This is an Clarification issued by **Tellepsen Builders**

CLARIFICATION for site logistics plan, concrete, precast, steel and glass

HCC Coleman Package 2

MAN/MATERIAL HOIST LOCATION		SITE MOCKUP WALL (OVERALL 24 FT x 20 FT TO SHOW VARIOUS COMPONENTS)

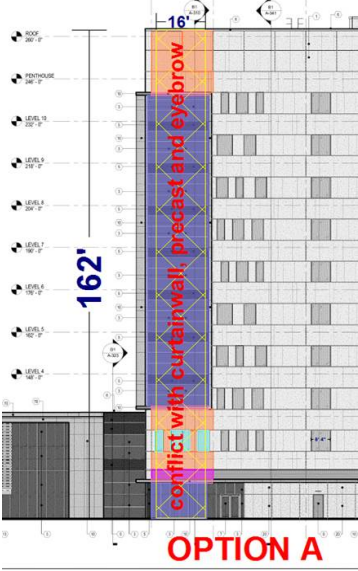
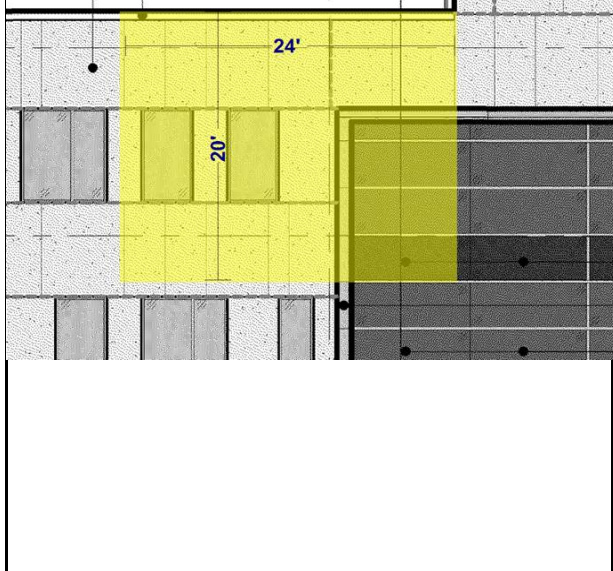
ITEM	DESCRIPTION	STATUS	RESPONSE
1	Will there be a Material Hoist Bay on this? If so, do we need an add to come back and erect those panels?		YES BTWN COLUMN LINE 7 & 8 ON WEST SIDE, We plan to have man/material hoist dismantle crane upsized to allow you to erect the top panels and lower panels after hoist removed, assuming two days for this. Provide an add cost to re-mobilize precast erection crew and deliver the panels. Assume precast panels for this location will be held at precast plant until needed. No room to leave a trailer on site. See sketch showing location below.
2	How do you plan on PRECAST being erected, By Elevation or Floor by Floor?		With the schedule proposed we will be at say 7 th floor pouring concrete, in two sequences, north half, south half, we had hoped you would be hanging panels below on an elevation, formworks will stick out about 3 to 5 feet, so you should be able to swing panels in to erect

3	Is there any perimeter netting we need to be aware of that needs to be coordinated with our precast install? If so, we do not typically get involved in the removal or reinstall of this netting.		No netting is planned, typically will have steel safety cables thru columns and toe boards
4	At the stairway areas, all treads, risers, and landings need to be completely constructed in order for our erectors to safely work off of to erect the panels in this area. Is there any issue with this?		Need to coordinate stair install and pouring treads and landings to meet your request here. Can you give us an add for scaffold if stairs are not in place?
5	Can we get a mix design on this? We drove by the site and took pictures, but our QC manager would like to make sure he is matching it exactly.		Mix design not available. Qualify what you are quoting if need be, bottom line is match existing, usually a trial and error at 12"x12" then make'em bigger as you get it close to acceptance. Ultimately we will want to do a site mock-up wall (usually an add from you) say a top and bottom spandrel, and a few vertical fill-ins, so we can set windows in them. Mock-up panels would need to be erected by you on a steel frame by others. This wall will be on site and stay for reference till end of job. Demo and removal by others at end of job. See partial sketch showing possible mockup configuration, say 24 ft wide X 20 ft tall. Provide an add alternate for precast in this site mockup wall.
